AMENDMENT TO THE DRAWINGS

REMARKS

FIG. 5

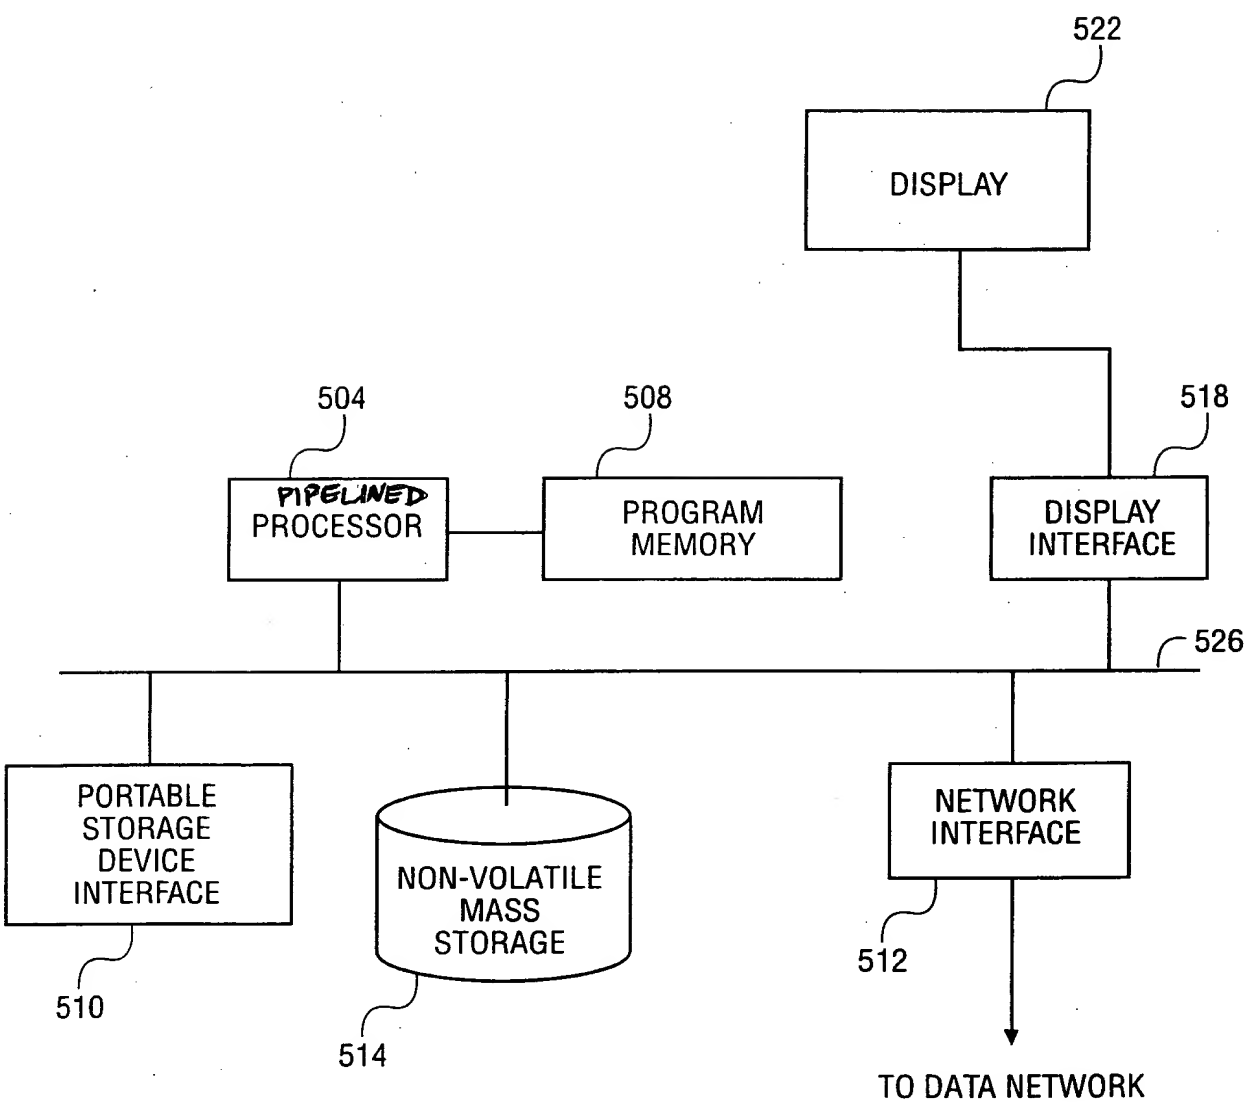
Enclosed is a replacement sheet for Fig.5 in which the word "PIPELINED" has been added to reference block 504.

Beginning on page 2 of the Office Action, the drawings were objected to for allegedly not showing the limitation in claim 28 of a hardware architecture that is pipelined. However, Applicant notes that the pipelined architecture of the processor in claim 28 need not be tied to the claimed methodology for computing transcendental functions. In the case of claim 28, this claim further limits its base claim 23, which is directed to a computer system, to one in which the processor has a hardware architecture that is pipelined. Since that is directed to conventional features only, a detailed illustration is not essential for proper illustration of the limitation in claim 28. Accordingly, to address the Examiner's concerns, Applicant has added the term "pipelined" to block 504 in Fig. 5, and inserted corresponding text in the Detailed Description (all without adding any new matter as the language is supported in the originally filed claim). Reconsideration and withdrawal of the objection to the drawings is therefore requested.
